MAJOR FACILITY SITING ACT CERTIFICATE AMENDMENT FOR IMPLEMENTING DRY DISPOSAL TECHNOLOGY AT COLSTRIP UNITS 3 & 4

On May 23, 2016, the Department of Environmental Quality (DEQ) received a request from Talen Montana, LLC, (Talen) to amend the Certificate of Environmental Compatibility and Public Need (Certificate of Compliance) for the Colstrip Steam Electric Station (Colstrip), located in Rosebud County, Montana. The Certificate of Compliance was issued in 1976 under the Major Facility Siting Act (MFSA), Section 75-20-101, *et seq.*, MCA.

The proposed amendment would allow Talen, the operator of the Colstrip Steam Electric Station, to implement dry disposal technology for the disposal of coal ash from Colstrip Units 3 & 4.

**Paste Plant
Location**

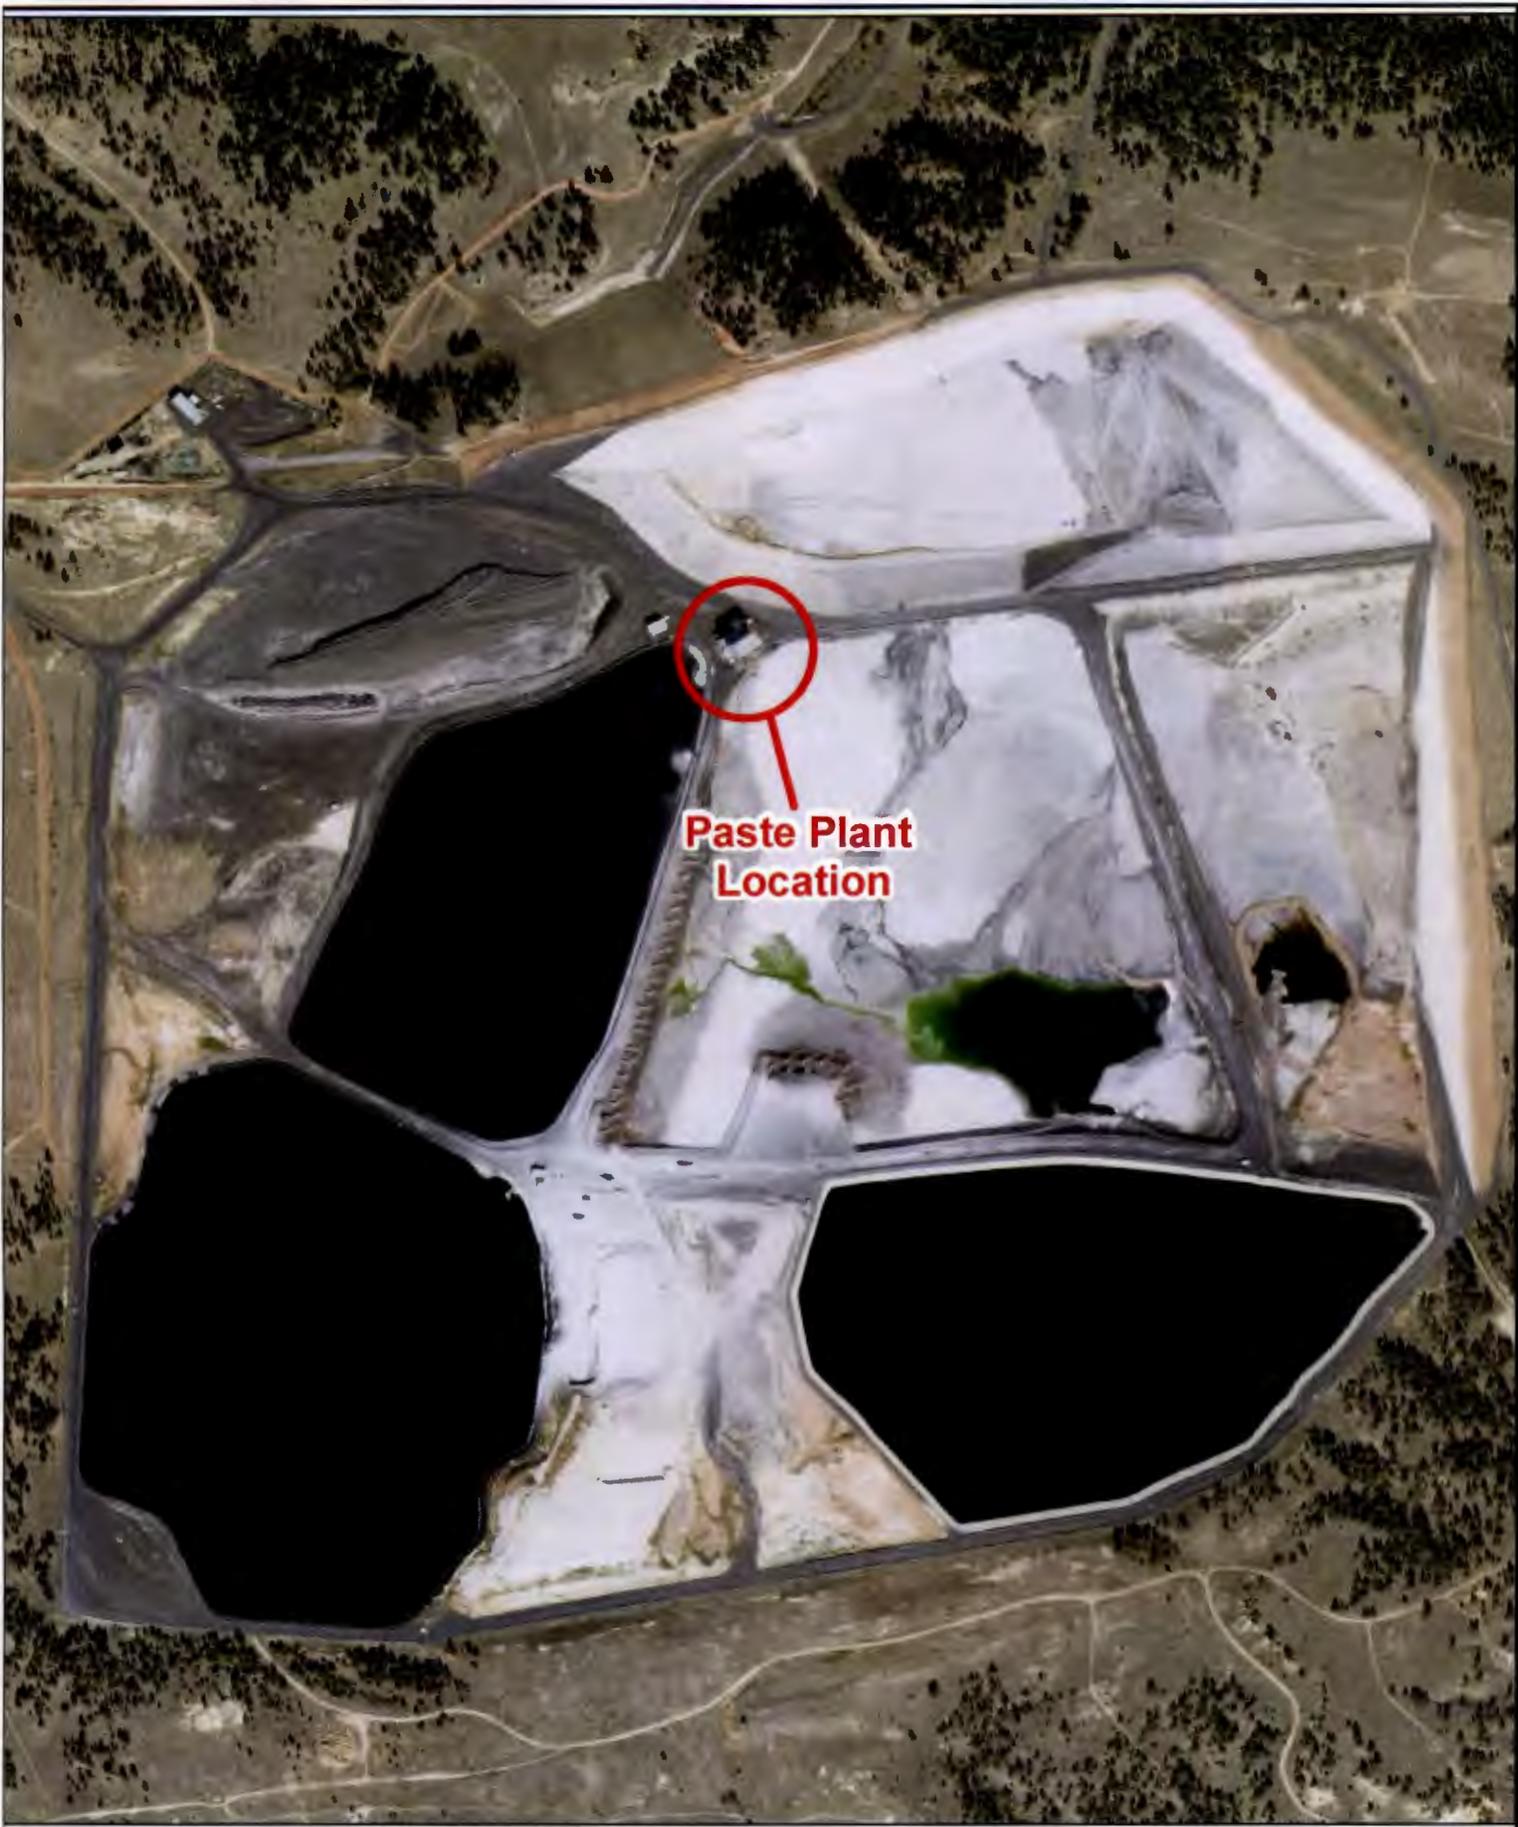
In accordance with Finding of Fact No. XXXI, byproducts from the Units 3 and 4 flue gas scrubbers are currently slurried by pipeline to the Units 3 and 4 Effluent Holding Pond. The Units 3 and 4 Effluent Holding Pond is located approximately 5 miles southeast of Colstrip. The slurry is partially dewatered in the paste plant, located within the perimeter of the Units 3 and 4 Effluent Holding Pond towards its center between Cells C and J. An aerial photograph depicting the paste plant within the perimeter of the Units 3 and 4 Effluent Holding Pond is attached hereto.

Under the proposed modification to Finding of Fact No. XXXI, byproducts from the Units 3 and 4 flue gas scrubbers would still be slurried by pipeline to the Units 3 and 4 Effluent Holding Pond. Talen would employ dry disposal technology located adjacent to the existing paste plant and within the perimeter of the Units 3 and 4 Effluent Holding Pond to further reduce the moisture of the waste matter. Dry disposal technology works by using filtration, vacuum, or other dewatering techniques to reduce the moisture of the paste plant material. The moisture in the paste plant material will be reduced by about an additional 15%, from approximately 35% down to about 20%. The target moisture is similar to that of moist soil.
